AMENDMENT ONE (1)

SUBJECT: IFB013BOCC17(C) Purchase & Installation of Perimeter Fence at Golden Grove Adult Correctional Facility & Detention Center, St. Croix

ADDENDUM # 1

IFB013BOCC17(C) – Bureau of Corrections Security Fence Golden Grove,
St. Croix

TYPICAL FENCE DETAIL

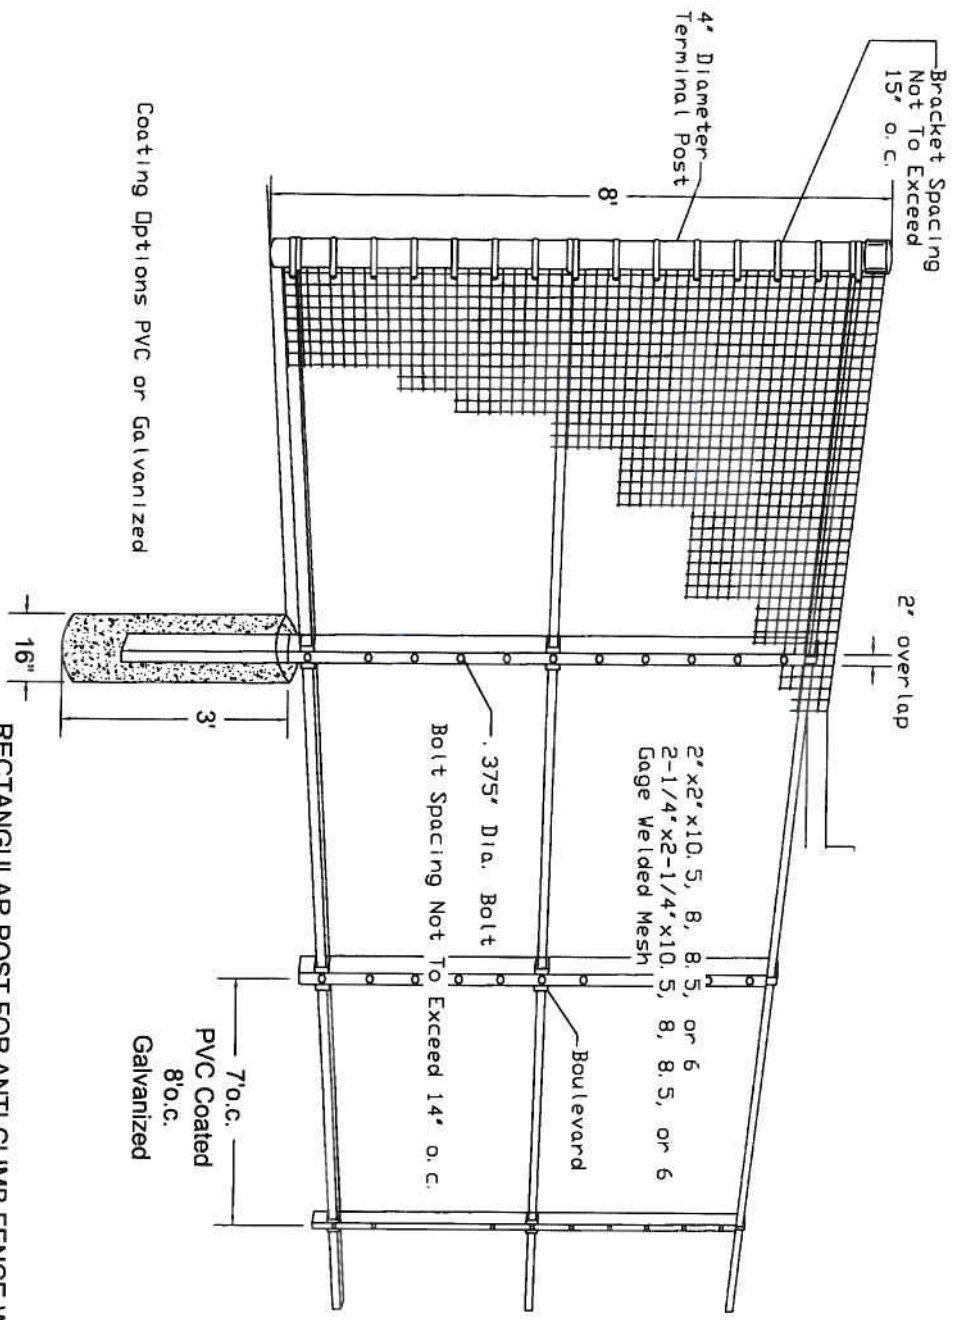
Question: Using the staggered fence elevation, what will be used to fill in the bottom?

Question: Will there be buried concrete wall at the fence line

Question: The standard wire gauges are 11.5, 10.5 and 9 for Anti Climb Fence. Eight (8) gauge would be nonstandard and more expensive. Is it an absolute requirement?

Question: Please provide the size of tube for the upright post and horizontal rails and thickness of the steel

Answer: A continuous concrete footing (12") will be constructed under the fence to hold the wire in place

Answer: Yes. Please see the revised drawings

Answer: This is a security fence for a prison to prevent prisoners from escaping the confined areas, thus No. 8 gauge will be used for this project.

Answer: Please see the revised drawings
